680HE Indicator

Display Field Replacement

Product: 680HE Display Board (PN 197034)

Figure 1. 680HE Front Panel

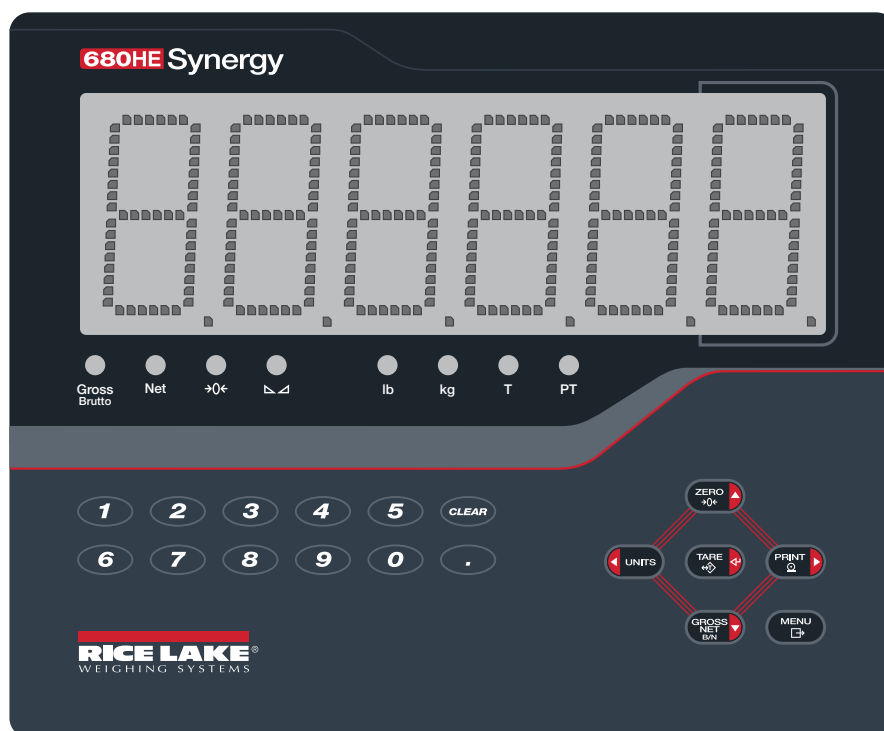
Issue: New display board revision is incompatible with older 680HE firmware

Solution: Update firmware to V1.05.01 or newer

NOTE: Refer to the 680HE Technical Manual (PN 197709) for firmware updating instructions.
